New Albany Planning Commission Agenda

Planning Commission Staff Report June 3, 2024 Meeting

PANDA EXPRESS DRIVE-THRU CONDITIONAL USE

PANDA EXPRESS VARIANCES

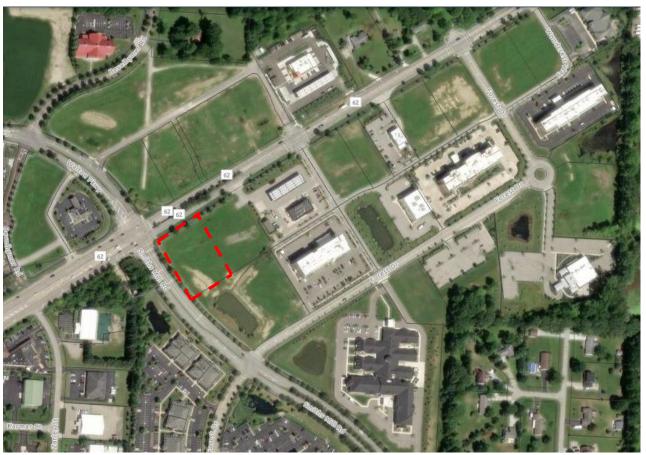
operable door on the Johnstown Road frontage does not preserve the "spirit and intent" of the zoning requirement. The intent of this requirement is to ensure that buildings maintain a presence on the street and not contain blank or "empty" building elevations so there is architectural vibrancy and interest on all sides of a building. The applicant could retain the existing service door on the Johnstown Road frontage and also add an additional operable door to the elevation.

Due to the auto-oriented nature of this zoning district, providing active and operable front doors on every elevation does not appear to be necessary since there is a hierarchy of streets. The applicant is still providing a high-quality designed building. Therefore, the design and non-active doors along Woodcrest Way appear to be appropriate.

However, the applicant should provide an active and operable door along the Johnstown Road and Smith's Mill Road street frontages as those since the property is located on a prominent corner and those are both the primary streets that the restaurant fronts. Not having an operable and active front along both Johnstown Road and Smith's Mill Road does appear to be substantial as it will alter the surrounding area and cause inconsistency among the street frontage. Having businesses and homes front onto streets by providing operable and active doorways is a design hallmark of the city of New Albany. All of the other businesses along Smith's Mill Road and Johnstown Road have an operable active front door that fronts those streets.
